UNITED STATES PATENT AND TRADEMARK OFFICE

APPLICATION NO.	FILING DATE	FIRST NAMED INVENTOR	ATTORNEY DOCKET NO.	CONFIRMATION NO.
10/019,195	06/03/2002	Hans-Jurgen Hannig	09646-00004	6251

Office Action Summary

DETAILED ACTION

FR-2,278,876

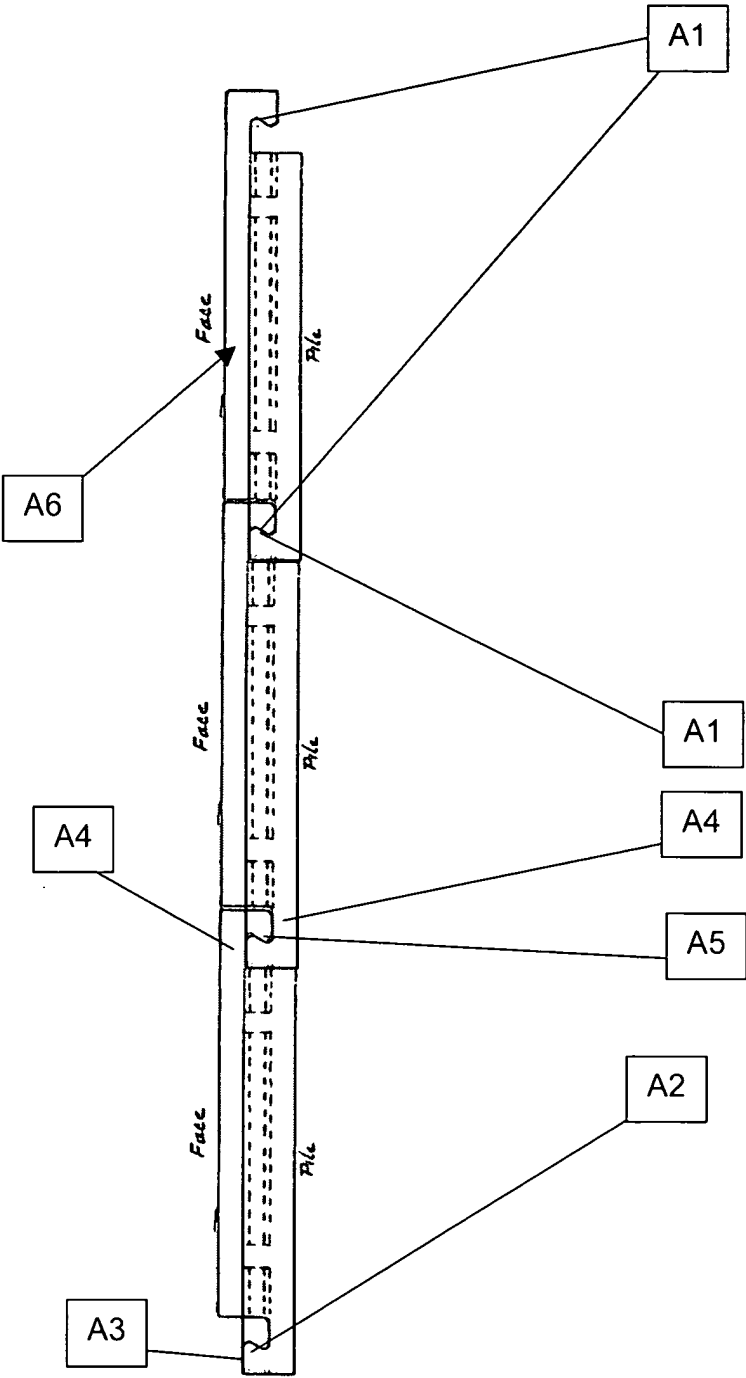
Claims 1, 2, 4 and 30 are rejected under 35 U.S.C. 102(b) as being anticipated by the French patent, 2,278,876 (see marked-up attachment).

Regarding claim 1, as best understood, the French patent discloses, in unlabeled figure, a fastening system characterized in that retaining surfaces **A1** of hook projections **A2** and complementary hook projections **A5** are inclined. The hook projections **A2** are reduced from free ends **A3** towards legs **A4**. One of the hook projections **A2** bears against the retaining surfaces **A1** of the complementary hook projections **A5**.

Regarding claim 2, as best understood, a first retaining profile of at least one pair of oppositely disposed retaining profiles is provided with a hook element formed from the leg. The leg projects approximately perpendicularly from the narrow side of the panel and arranged at a top side of the panel. A hook projection **A2** is arranged at the free end of the leg. The hook projection faces towards an underside of the panel. A second retaining profile of at least one pair of oppositely disposed retaining profiles is opposite the first retaining profile and provided with a hook element formed from the leg. The leg projects from the narrow side of the panel and arranged at an underside of the panel. A hook projection **A2** is arranged at the free end of the leg of the second retaining profile. The hook projection faces towards the top side of the panel.

Regarding claim 4, as best understood, the retaining surfaces **A1** engage with the complementary hook projections **A5**. Applicant is reminded that the method of engaging the retaining surfaces **A1** with the complementary hook projections **A5** is not germane to the issue of patentability of the device itself. Therefore, this limitation has been given limited patentable weight. See MPEP ' 2113.

Applicant has argued that the figure provided by the Examiner does not appear in the French publication. Applicant is correct. The examiner merely fabricated what is suggested by the specification (see attachment of the English abstract). It is inherent that several tiles make-up a floor covering. One of ordinary skill in the art will readily know that putting tiles of the French patent together make-up a floor covering as shown
